SERVICE BULLETIN

SVR 09-003

Product: 2009 WS Swather & Grain Belt Headers

Re: Improperly located bolt on 2009 WS & Grain Belt Headers shipped from factory prior to Jan. 29, 2009

Solution: Check tables and remove bolt if found, **bolt must be removed to prevent draper damage.**
Figure 1

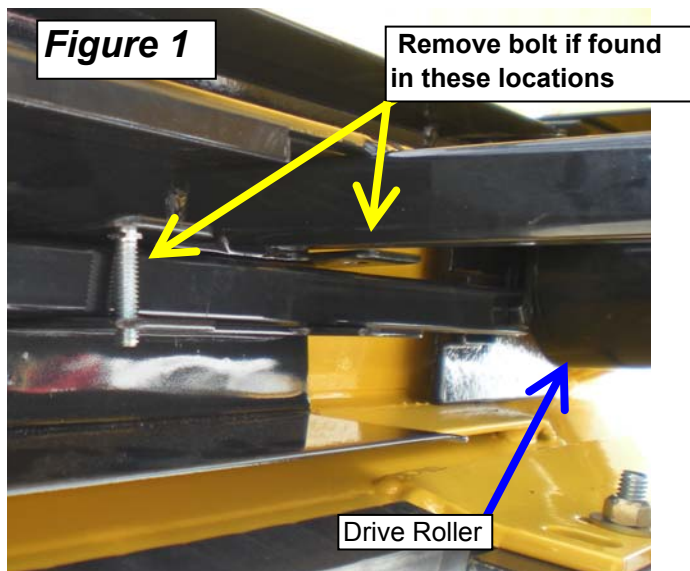
Problem: A bolt may have been incorrectly attached to either right or left deck, near the drive roller end.
